# UNITED STATES PATENT AND TRADEMARK OFFICE

09/781,246

<b>Office Action Summary</b>	<b>Application No.</b> 09/781,246	<b>Applicant(s)</b> CHEN, MU-LIN	
	<b>Examiner</b> D. S. Meislin	<b>Art Unit</b> 3723

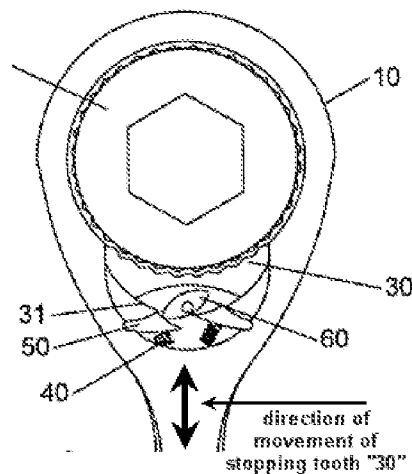
The stopping tooth "30" is disclosed as being linearly movable.

With one resisting element "50" being held out of engagement with the stopping tooth "30", it would appear that the resisting element "50" in engagement with the stopping tooth "30" would prevent the vertical movement of the stopping tooth "30" to allow for ratcheting. Additionally, if the resisting element "50" in engagement with the stopping tooth "30" is movable in the vertical position, it is not clear how the stopping tooth "30" could be locked in position to allow for rotation of the workpiece. Also, it is not clear how the resisting elements "50", in engagement with the stopping tooth "30" would prevent the vertical movement of the stopping tooth "30". It is also not clear how

the direction block would maintain its angular position since the block is able to pivot as the springs "40" would provide a force thereto. The device does not appear to be operable as disclosed.
